Application for Works Approval Amendment

Choose an item.	W5800/2015/1
Works Approval Holder	Opalvale Pty Ltd
ACN	106 512 896
File Number	DER2014/003195
Premises	Salt Valley Road Class II Landfill Chitty Road, HODDY'S WELL WA 6566 Legal description – Part of Lot 11 on Deposited Plan 34937 Certificate of Title Volume 2535 Folio 391 As depicted in Schedule 1 of W5800/2015/1
Date of Report	4 November 2020
Proposed Decision	Revised works approval granted

This Amendment Report documents the assessment of potential risks to the environment and public health from proposed landfill design changes. As a result of this assessment, Revised Works Approval W5800/2015/1 has been granted.

Figure 1: Typical fine grained soil protection on sideslopes

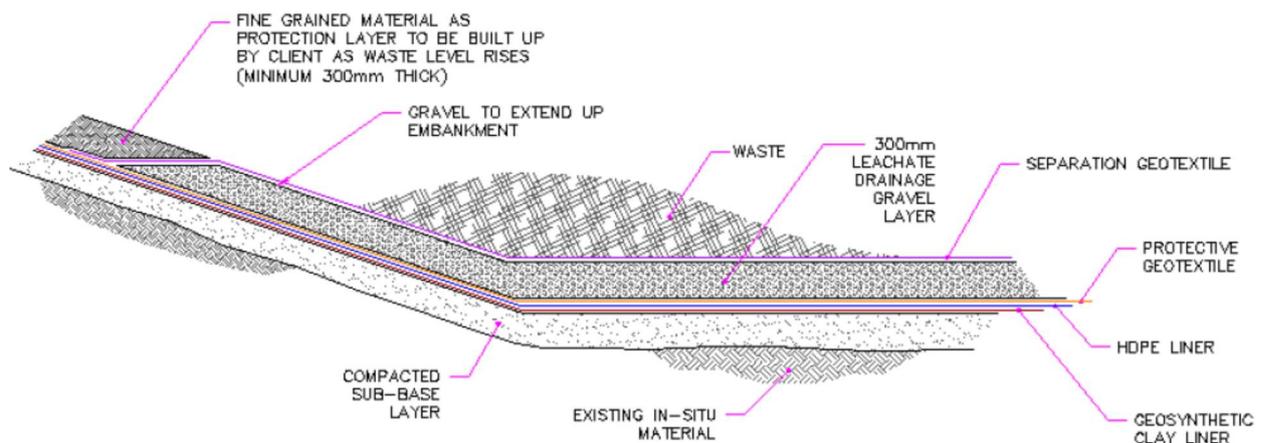
To address these identified liner integrity issues, the Works Approval Holder is proposing to place a fine grained protection layer on top of the existing cushion/protection geotextile layer. The works approval holder states that *“even though the exposed cushion geotextile has reduced in strength due to UV degradation, the placement of a fine grained protection layer above the geotextile will be adequate to protect the lining system during operations at the Site. The reduced strength of the cushion geotextile in combination with the fine-grained protection layer is adequate to fulfil the design intent for protection of the underlying geomembrane”*.

The applicant is proposing to undertake the placement of the fine grained protection layer progressively in campaigns. The placement of the fine grained protection layer progressively will ensure that the fine-grained protection layer is covered with waste in a methodical manner and will not deteriorate/erode (via wind or rainfall) prior to the placement of waste adjacent to the sideslope. The below figure shows a typical fine grained soil protection layer on sideslopes, as proposed by the applicant.

2. The Delegated Officer notes that the fine grained protection layer is proposed to be placed on top of the existing cushion/protection geotextile layer above 4.5 m and where progressive aggregate placement has not already undertaken.
3. The fine grained protection layer transfers a lower pressure to the geomembrane than a leachate collection aggregate layer.
